1 4/28/88 LLS LOC STUMP BURIAL AREA	THE MATHISEN COMPANY	DRAWN BY:	P.M.S.
	P.O. Box 578 Indian Trail, N. C. 28079-0578	APPROVED BY:	N.A.M.
	REZONING MAP (TAX PARCEL NO 49-291-04)	SCALE:	1" = 60'
	EXISTING INSTITUTIONAL to R-9 MF(CD)	DATE:	11-23-87 SHEET 1 of 1

SUBJECT: Administrative Approval for Pet. #88-2(c) to add onsite Demolition Landfill.

THE MATHISEN COMPANY	DRAWN BY: N.A.M.
P.O. BOX 578 -- INDIAN TRAIL, N.C. 28072-0578 -- TEL. 704-852-1193	APPROVED BY: N.A.M.
COLVILLE TWO	SCALE: 1" = 50'
SITE PLAN	DATE: 3-5-88 SHEET 1 of 7

SUBJECT: Administrative Approval for Petition No. 88-2(c) By The Mathisen Company Tax Parcel # 049-291-04

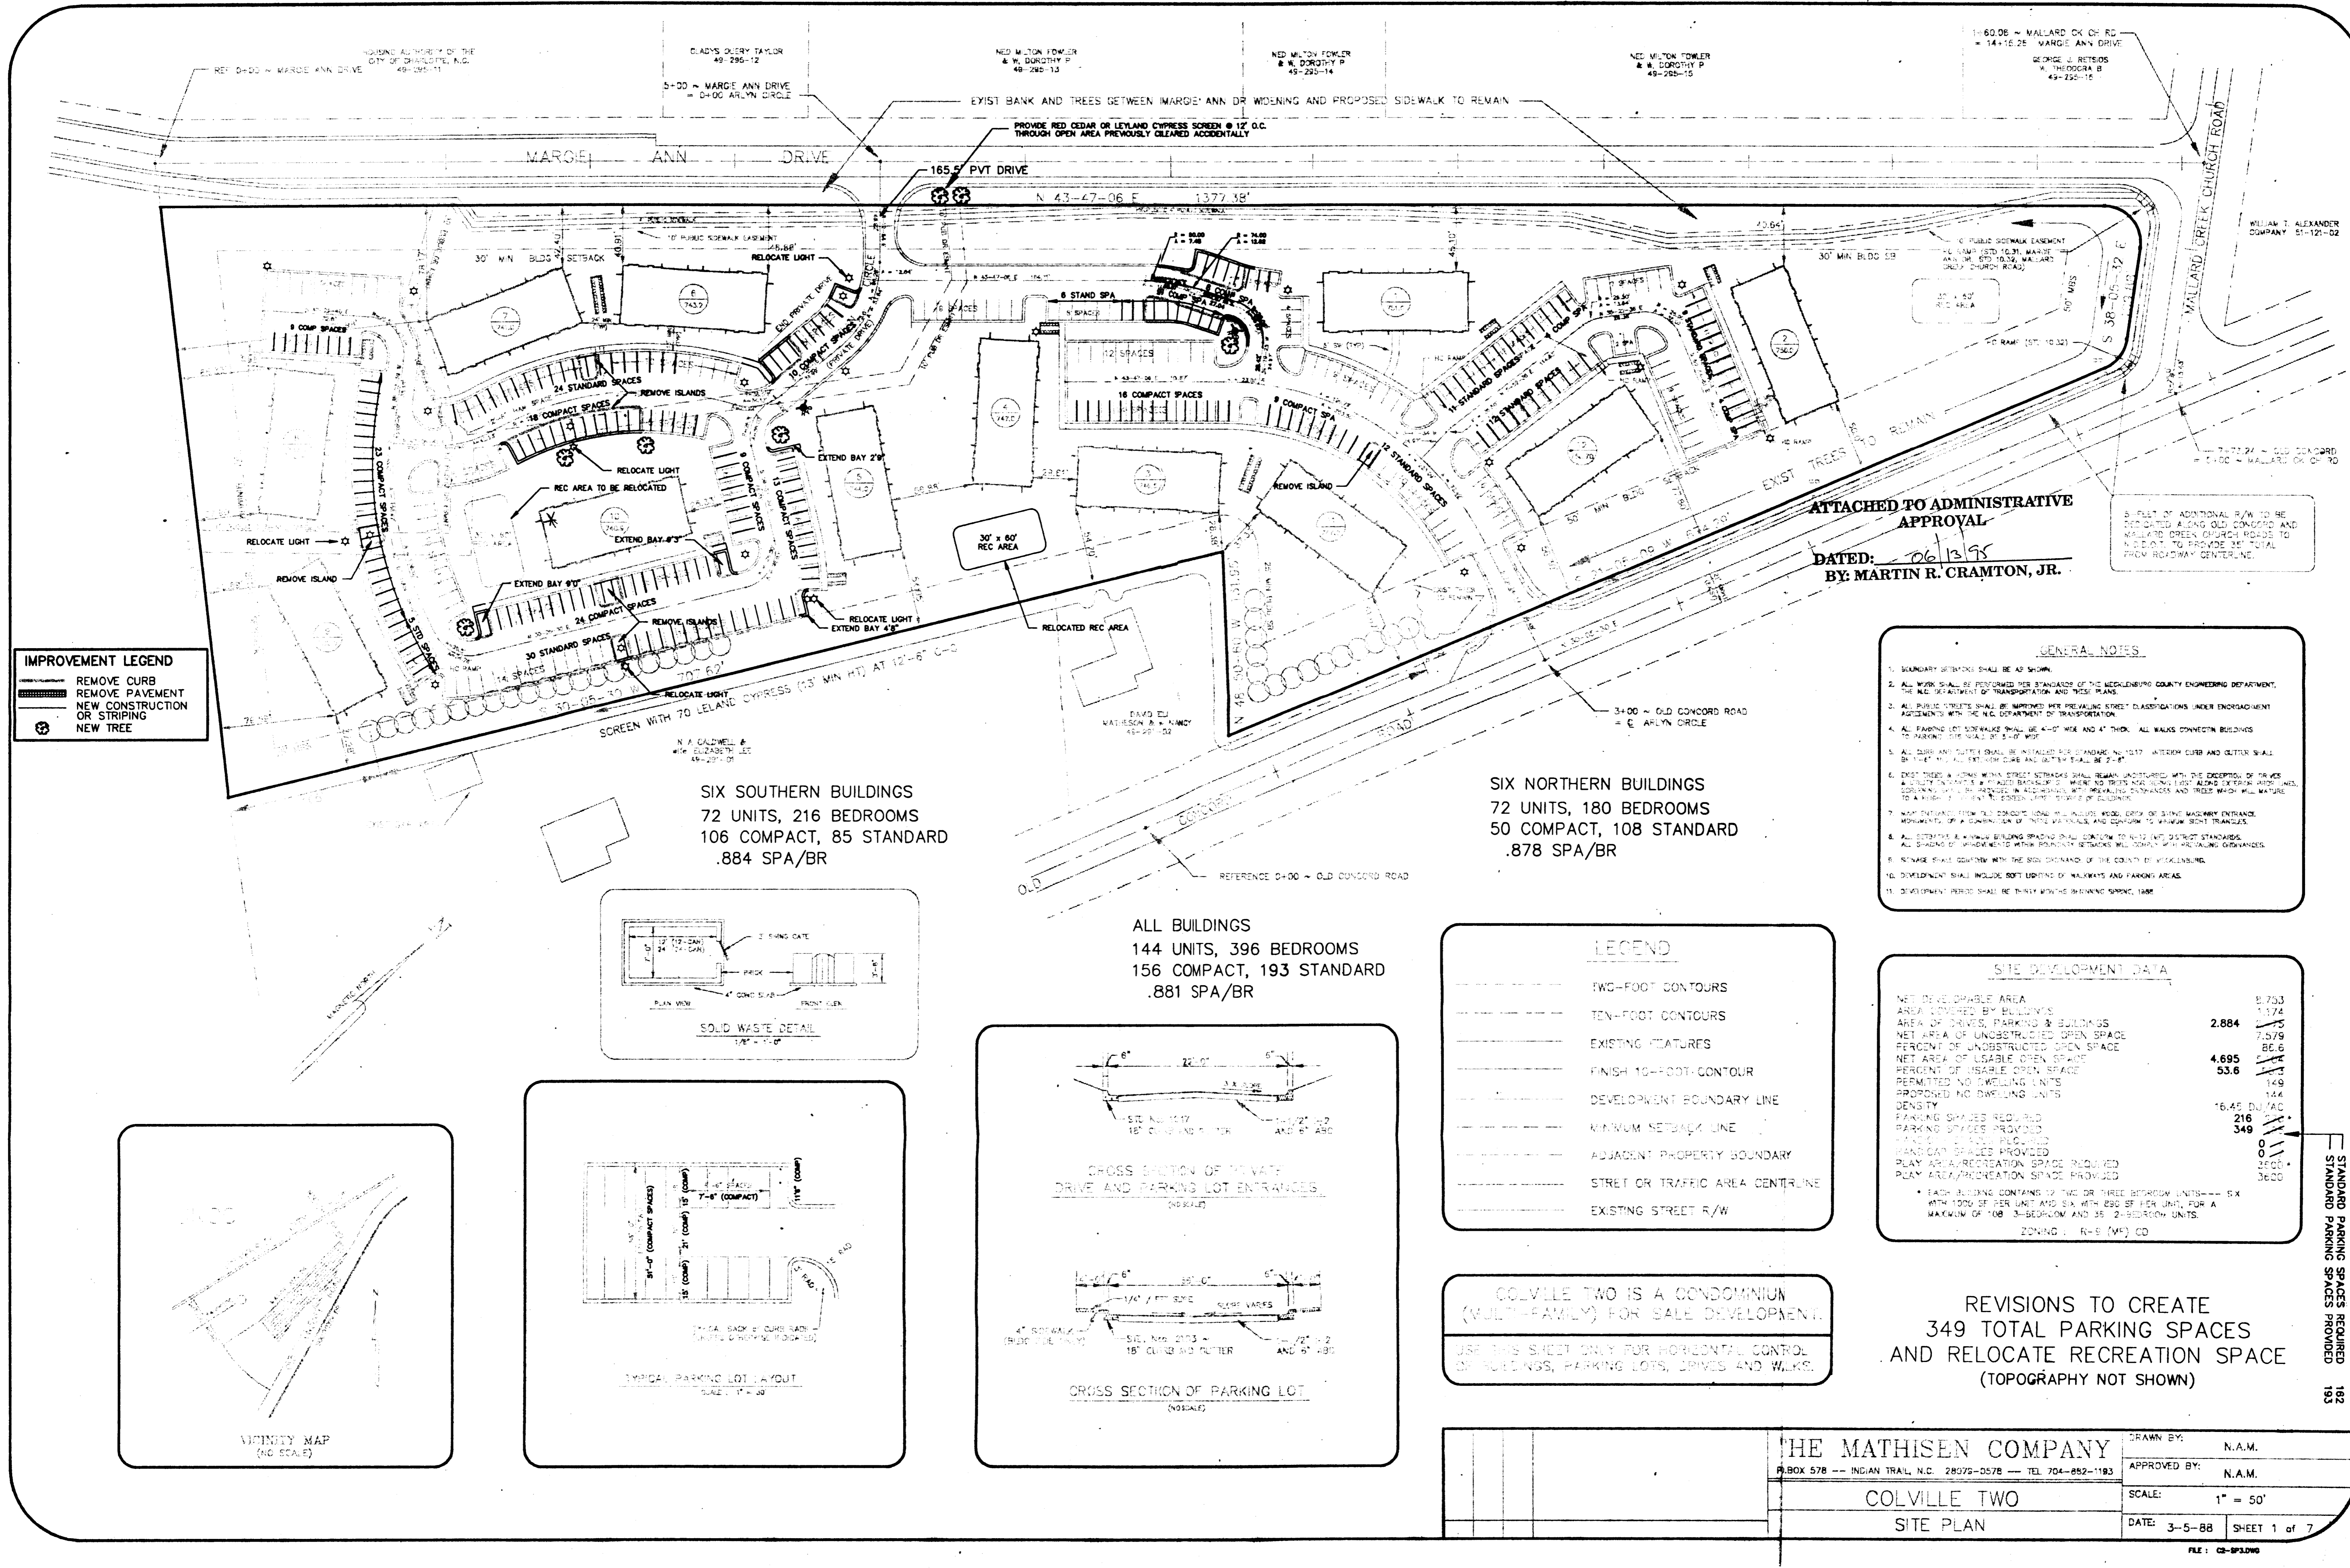
Enclosed please find a revised copy of the site plan for petition #88-2(c). The site plan has been revised to add a onsite Demolition Landfill. The location and the addition of this onsite Demolition Landfill is within the requirements of the approved Conditional District Plan.

Pursuant to my authority as outlined in the zoning ordinance, I am administratively approving this plan. Please use it when evaluating requests for building permits.

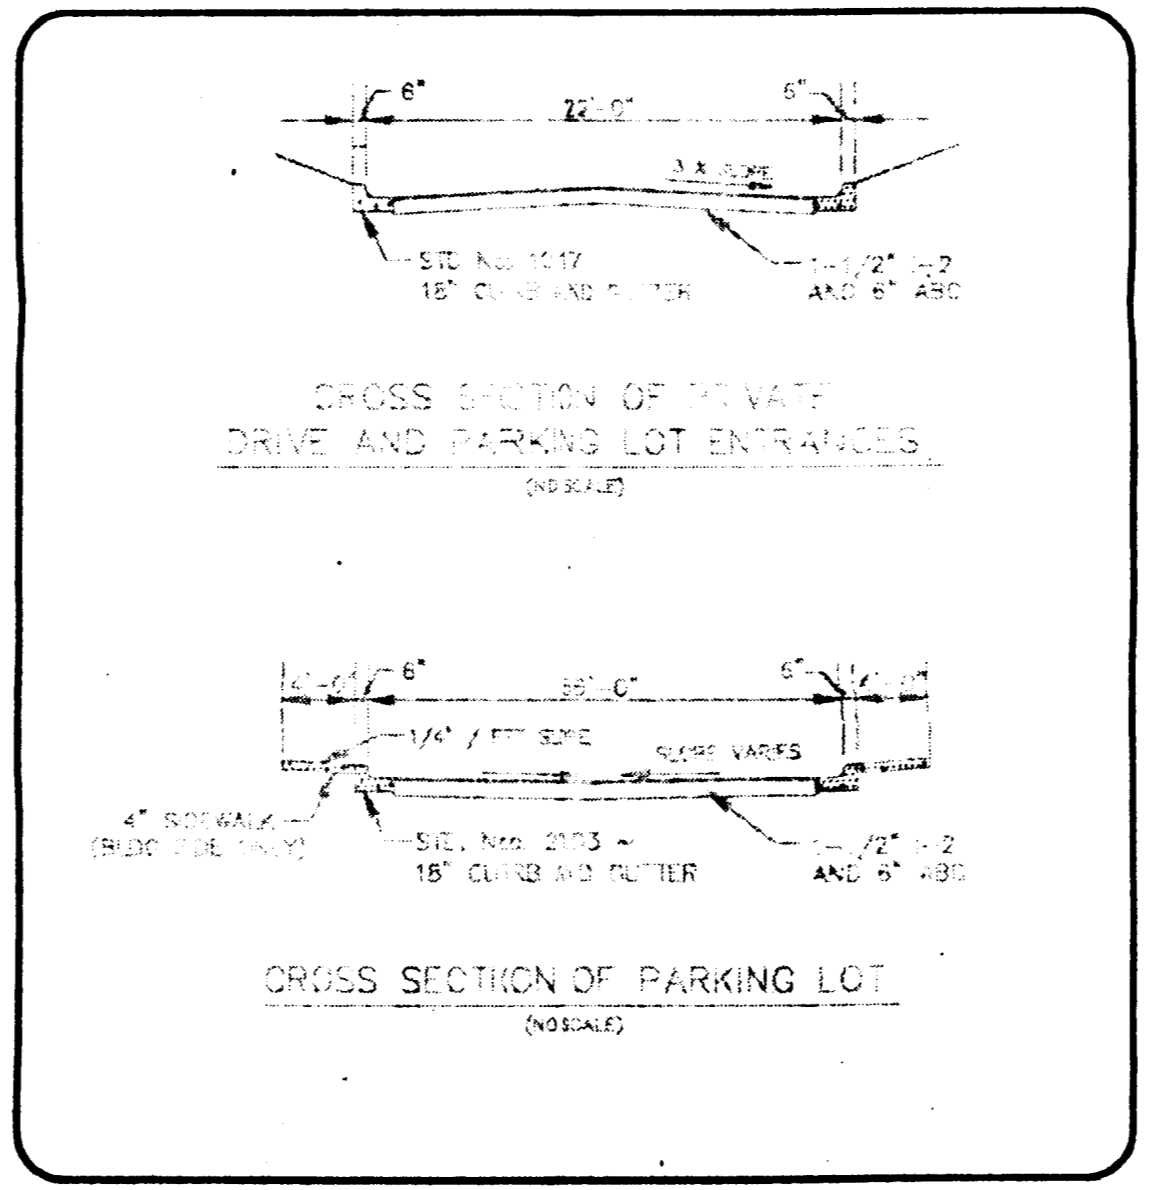
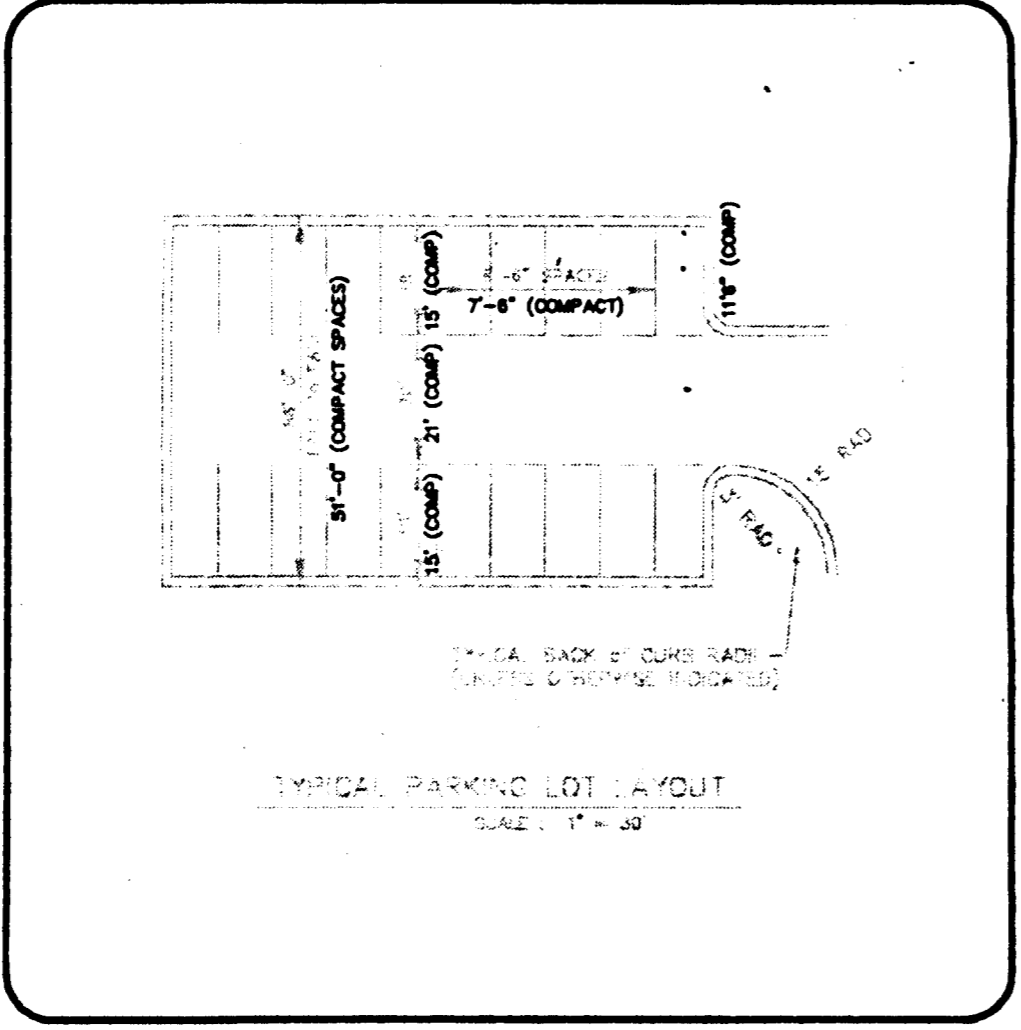
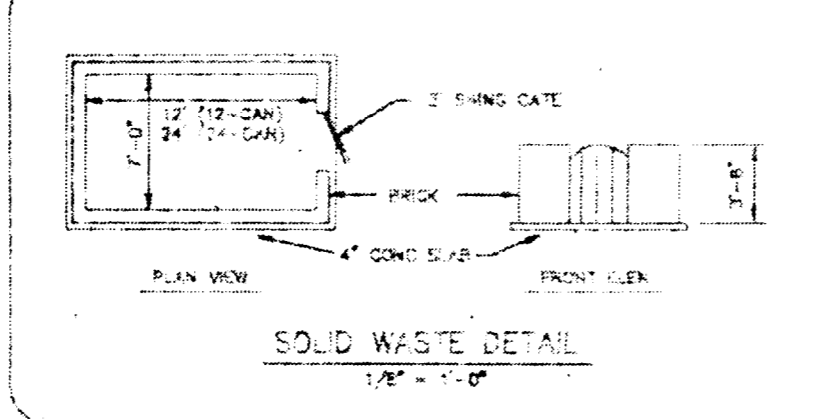
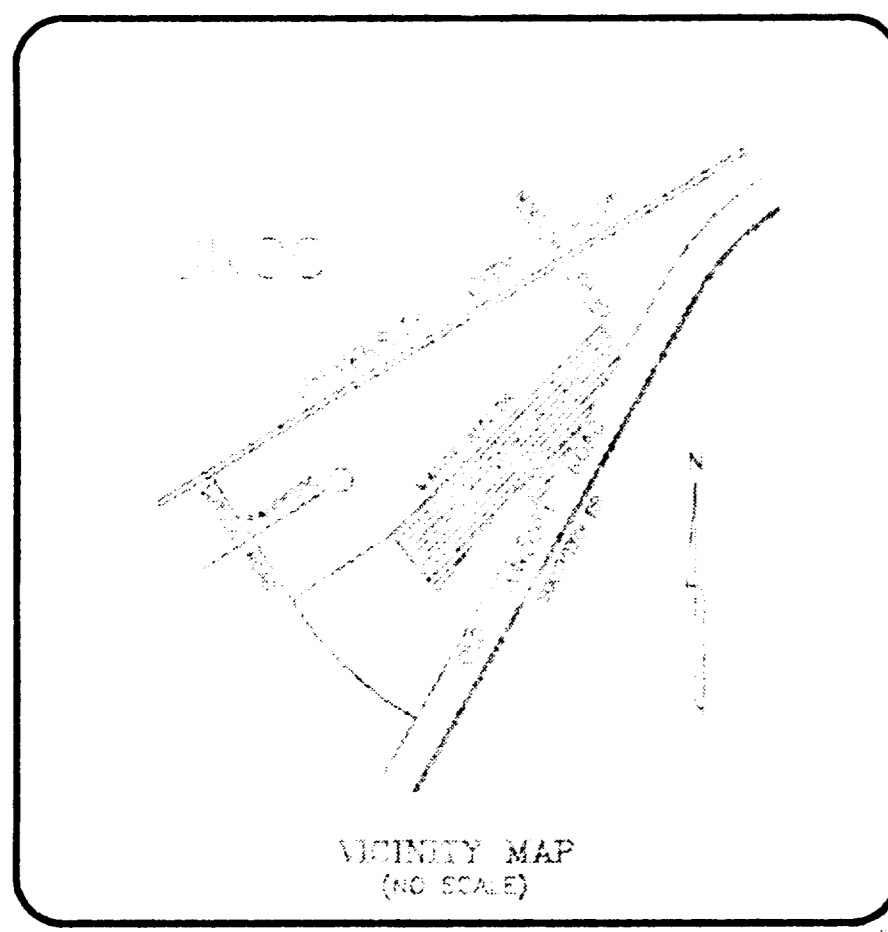
REVISIONS TO CREATE
 349 TOTAL PARKING SPACES
 AND RELOCATE RECREATION SPACE
 (TOPOGRAPHY NOT SHOWN)

Attached is a specific Multi-Family Plan for the above mentioned rezoning petition. The plan has been revised to allow the number of required spaces to be calculated under the current standard of 1.5 spaces per unit versus the old requirement of calculating spaces based on unit size. This change will allow the developer to construct additional compact parking spaces. As per the zoning regulations in effect at the time the land was developed the developer was required to provide 270 parking spaces. Up to 25% of these spaces could be compact spaces plus any spaces over the required number. On the latest approved plan the developer had proposed to construct 335 parking spaces, of these parking spaces 132 were to be compact spaces. Under the proposed plan the total number of spaces provided will be 349 of these 156 spaces will be compact spaces. This proposed plan represents an increase in the total number of spaces. This plan will provide 14 more spaces and increase the number of compact spaces to 24. This increase in compact spaces is possible by allowing the total number of required spaces to be calculated at 1.5 spaces per unit which in turn reduces the required number of spaces allowing all the spaces over the minimum to be compact spaces.

Also attached is a plan for the same project indicating an increase in the total number of parking spaces provided from 349 to 396 and an increase in the total number of compact spaces to 234. This plan represents a possible increase in the total number of parking spaces that may be undertaken by the home owners association if they choose to at a later date.

The increase in the total number of parking spaces has become necessary due to the large number of students that occupy the units and own cars. It is the intent of this administrative approval to allow more parking spaces to be placed on the site by allowing more of the spaces to be compact spaces. It is not intended to reduce the total number of required spaces. Therefore, at no point in time can the total number of required spaces fall below what was originally required 270 spaces.

Since this change is minor and does not reduce the yards at the exterior of the property I am administratively approving this plan. Please use these plans when evaluating requests for building permits, land use permits and certificates of occupancy.
